**CITY OF CEDARBURG
A MEETING OF THE SITE AND ARCHITECTURAL REVIEW BOARD
TUESDAY, NOVEMBER 18, 2025 – 8:30 AM**

**CITY OF CEDARBURG
SITE AND ARCHITECTURAL REVIEW BOARD
October 21, 2025**

Property Owner:	James Moe and Laura Scott
Applicant:	Sue Thierfelder/Thierfelder Builders, Inc.
Request:	Recommendation to Plan Commission to approve infill residence site and architectural plans.
Current Zoning:	Rs-5 Single-Family Residential District
Current Master Plan Classification:	Medium Density Residential
Surrounding Zoning/Land Use:	<u>North:</u> Cedar Creek <u>South:</u> Rs-5 Single-Family <u>East:</u> Rs-5 Single-Family <u>West:</u> Rs-5 Single-Family
Lot Size:	~.58 Acres (~25,265 sq. ft.)
Location:	W60 N810 Riveredge Drive

Certified Survey Map No. _____

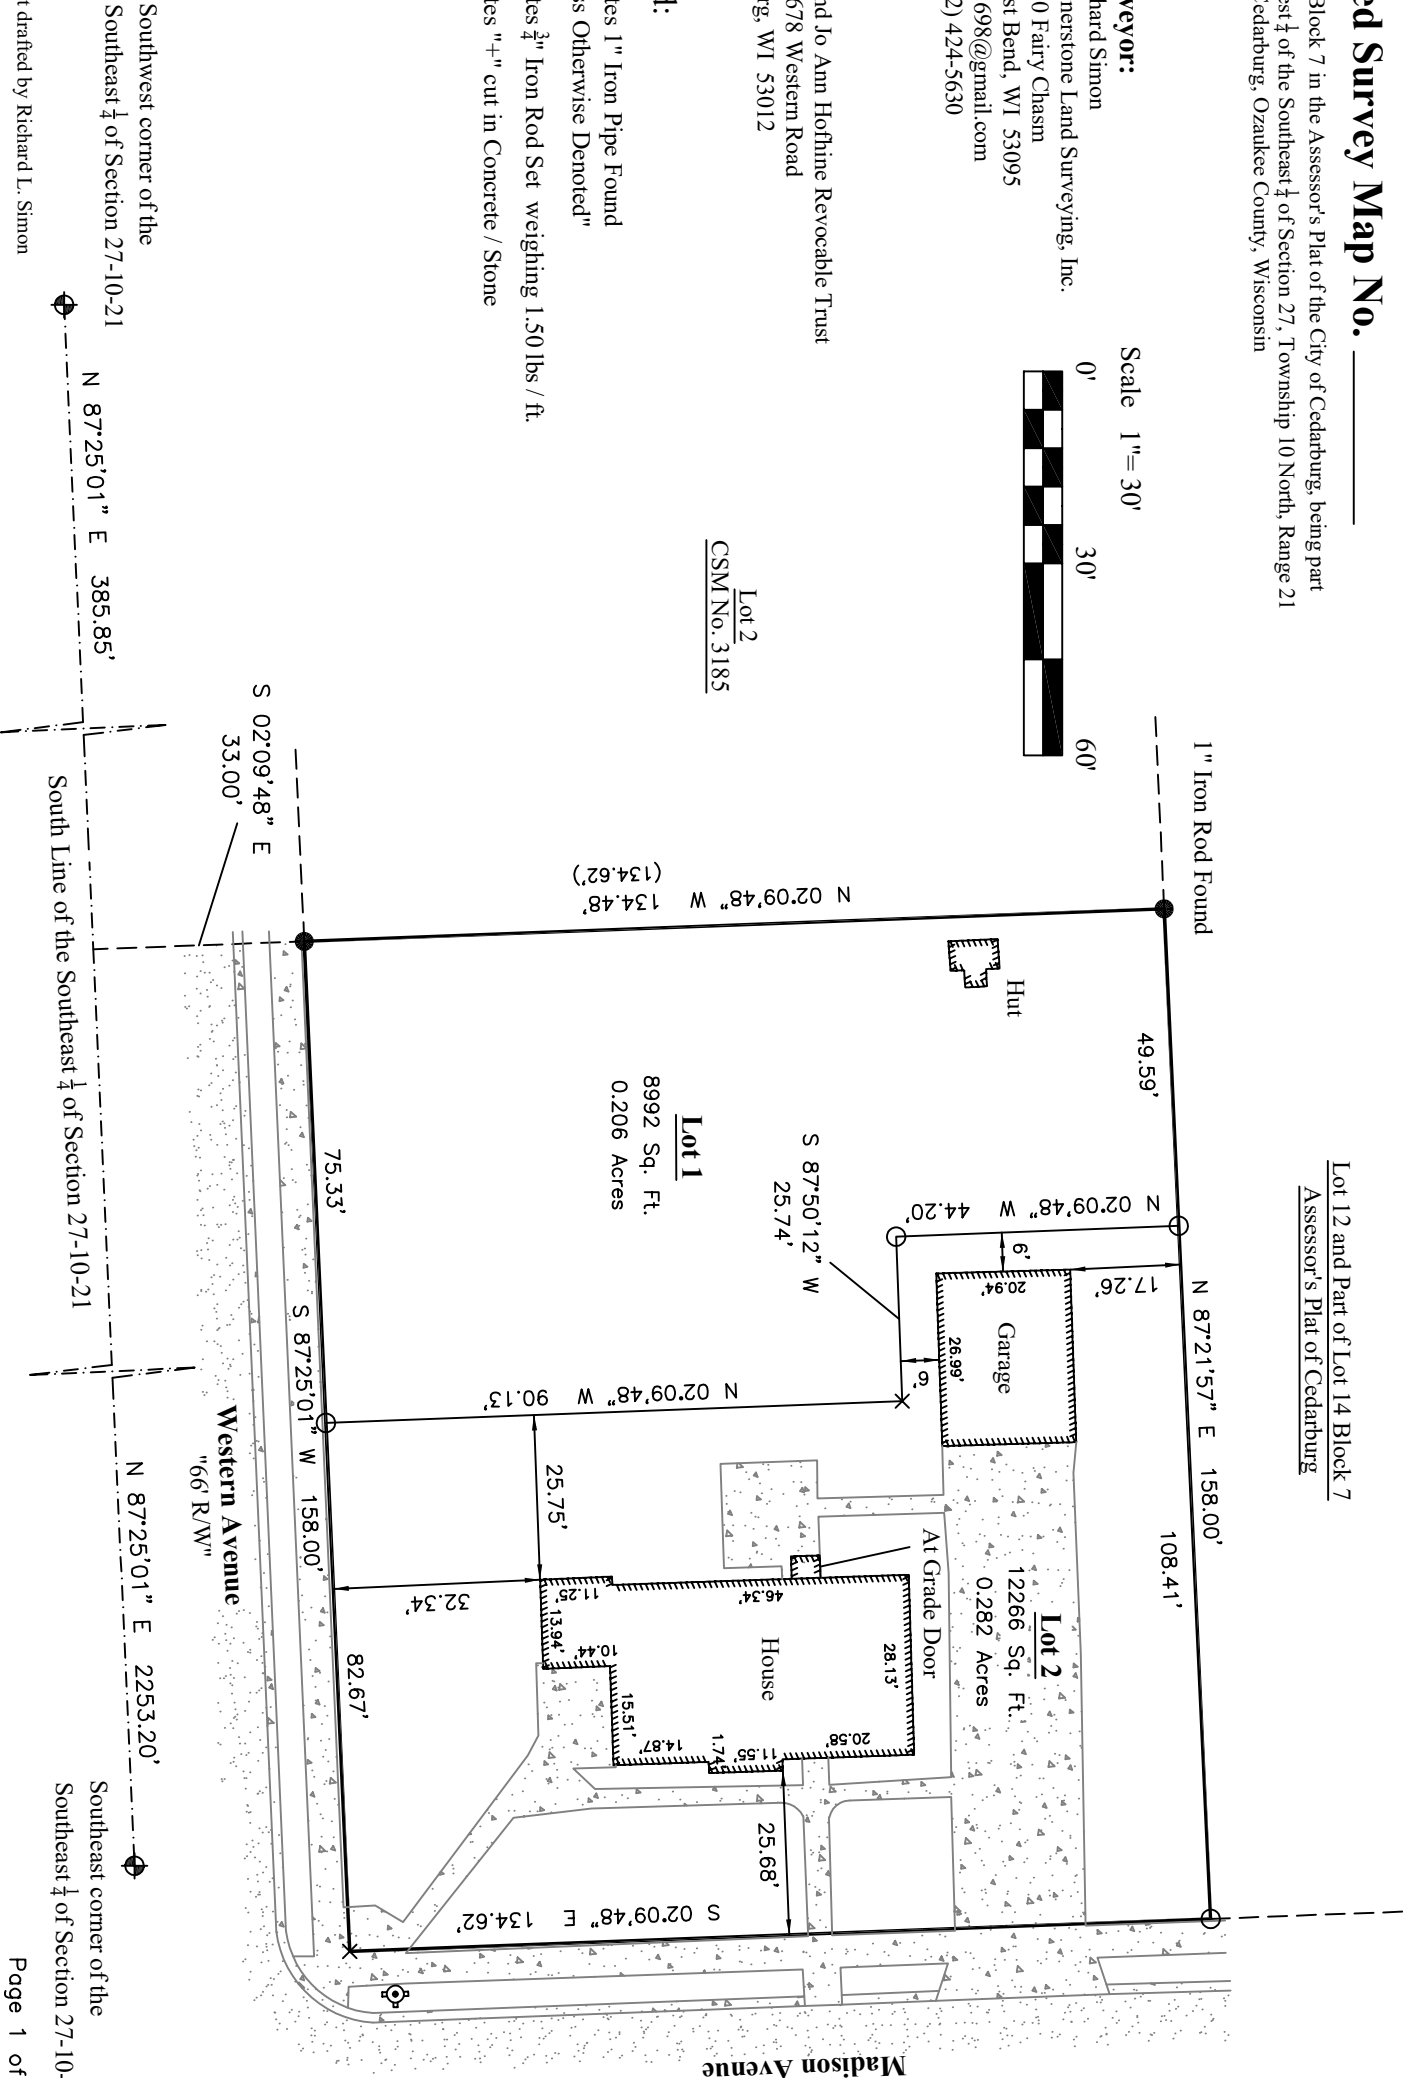
- 1) A note shall be placed on the face of the CSM informing that the vacant Lot 1 meets the definition of an “Infill Lot” under the City of Cedarburg Code. Therefore, any future plans for construction of a structure on Lot 1 will be subject to prior review and approval of the site and architectural plans by the City of Cedarburg Plan Commission prior to issuance of a building permit.
- 2) All specimen trees field located by the City Forester on Lot 1 of the CSM shall be added to the face of the CSM along with a note stating that the specimen trees are required to be preserved in accordance with [Section 6-4-14 of the City Code of Ordinances](#) and the City’s Tree Preservation Guidelines.

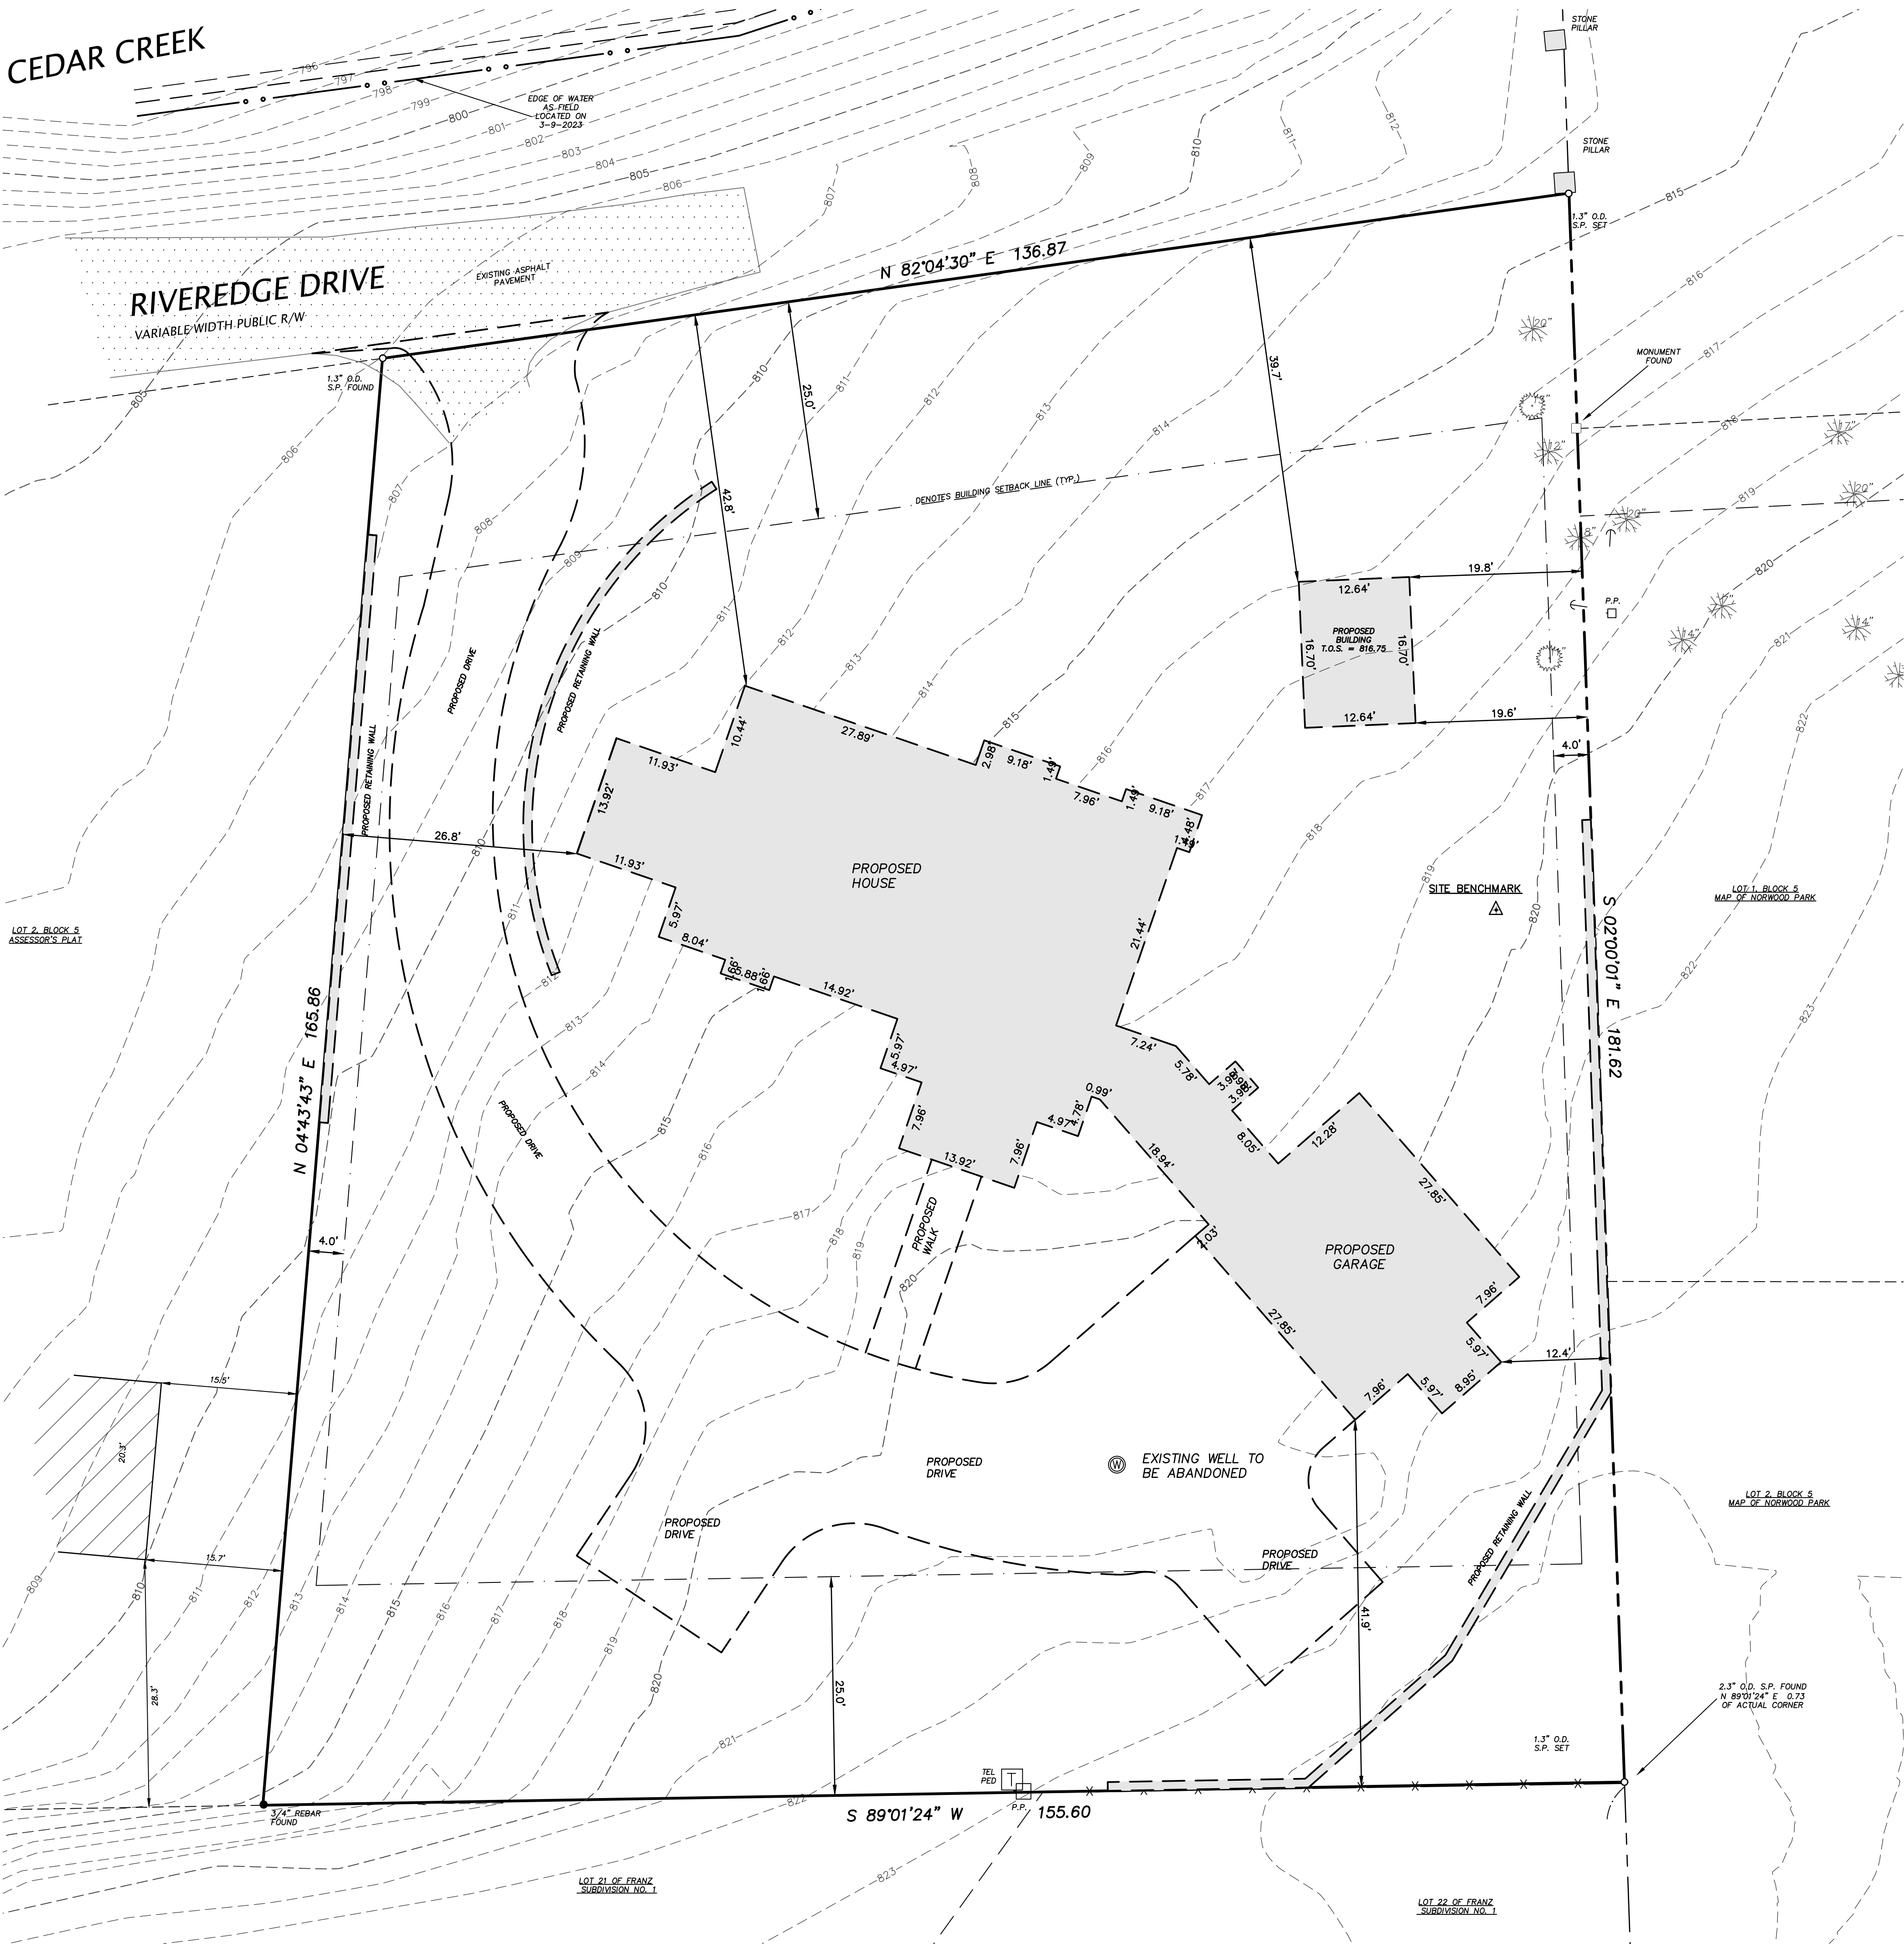
As presented, this plan complies in all respects with the bulk and spatial requirements of the Rs-5 Single-Family Residential Zoning District, such as setbacks, maximum floor area ratio, maximum lot coverage, minimum home size, and maximum building height, among other things.

The proposed greenhouse accessory structure also complies with respect to permitted size and quantity of accessory structures. Accessory structures are required to be located in the rear yard. Given the proposed positioning of the home on this lot, the Planner views the greenhouse location as compliant with that requirement.

ALTERNATE HOUSE AND GARAGE LOCATIONS

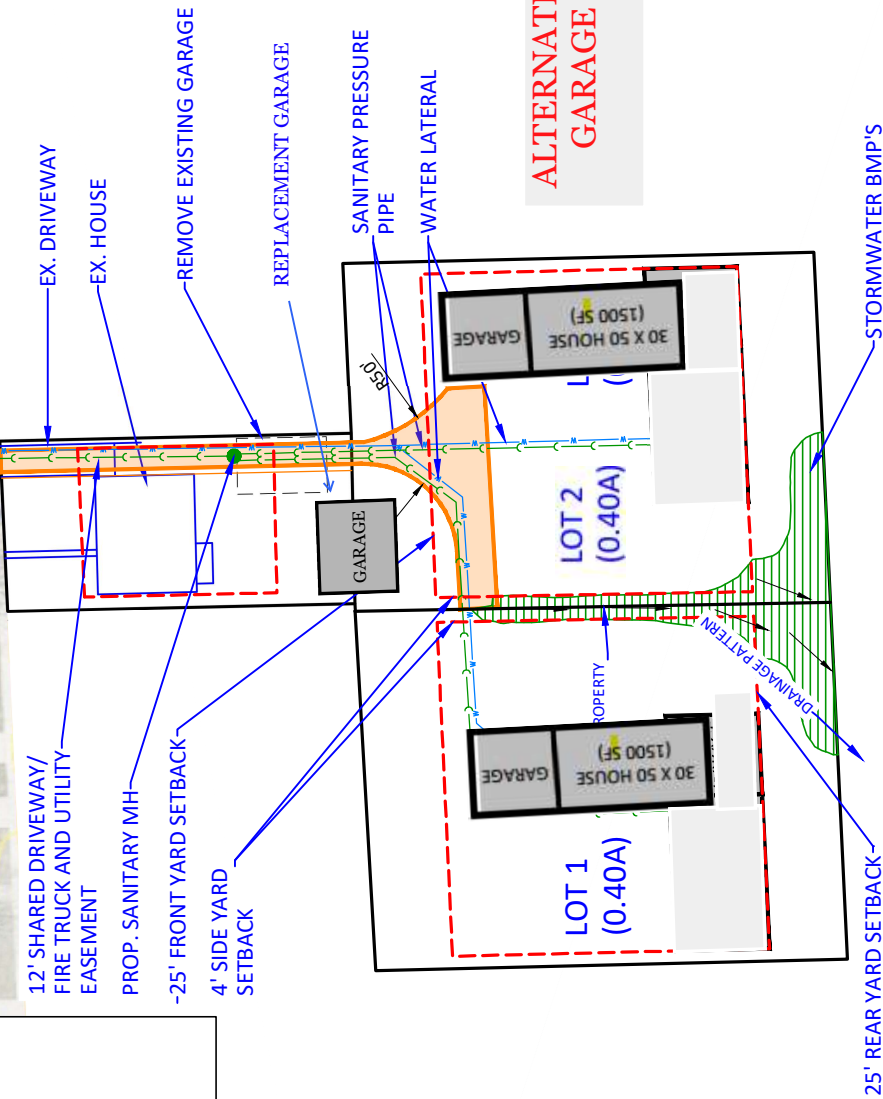
Section 13-1-27(b) of the City Code provides that “all lots shall abut upon a public street, and each lot shall have a minimum frontage of 30 feet”. While the existing platted lot is presumed to have buildable status as a legal nonconforming lot, creation of a new lot lacking this minimum frontage would require approval of a variance.

- 1) Applicant to secure a variance or alternate solution to exempt them from the 30-foot minimum street frontage requirement before returning to the SARB and Plan Commission with a Certified Survey Map (CSM) in support of this project.
- 2) Applicant is on notice that the existing and proposed new vacant lot meet the City’s Code definition of an infill lot. Accordingly, any future plans to construct a home on these lot(s) will require review and approval by the Site and Architectural Review Board (SARB) and the Plan Commission prior to issuance of a building permit.
- 3) Applicant to satisfy the requirements of the various departments as set forth in their review/comments (see above).
